VEMS v3 genboard checklist before final assembly (srl 9900-10499)

If your VEMS v3 genboard's serial number is 9900-10499 please follow these instructions during assembly. On assembled ECUs normally done when applicable, but check if converting (eg. adding 3rd trigger or mcp3208/ch5 analog input).

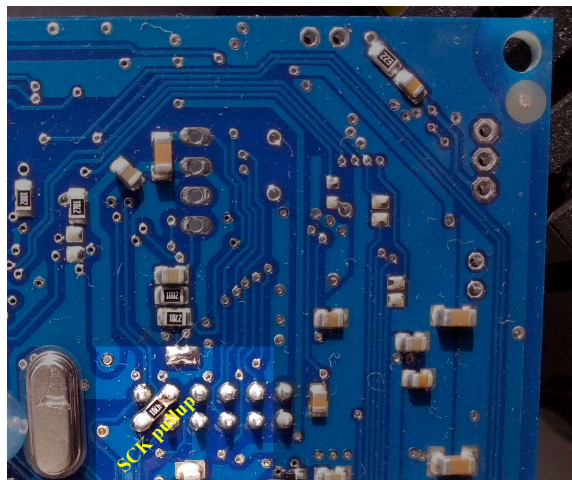
- Check **reset circuit**. Solder the components if not already populated (for lower „reset impedance” and better noise suppression eg. during powerup):

Creset = 1µF (parallel with Ropt, under Ropt on the picture). The only mandatory component.

Ropt = 100k is optional, piggybacked on top of Creset (Creset is required!)

Ru26 = 10k reset pullup (can be higher value, or left off if Ropt is not populated either)

R53 = 0R (or 1k). Already populated (do NOT remove).

SCK pullup = 4k7 diagonally on ISP header, bottom side

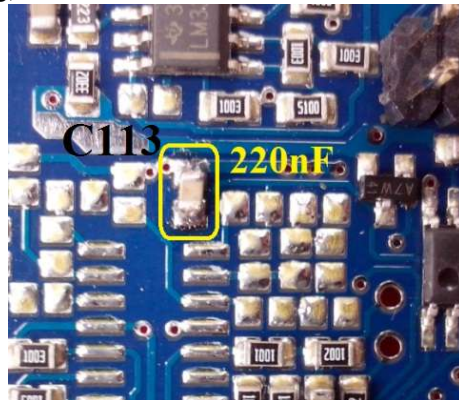
- Check **SCK pullup** required. Solder the components if not already populated. (on ISP header, bottom side)
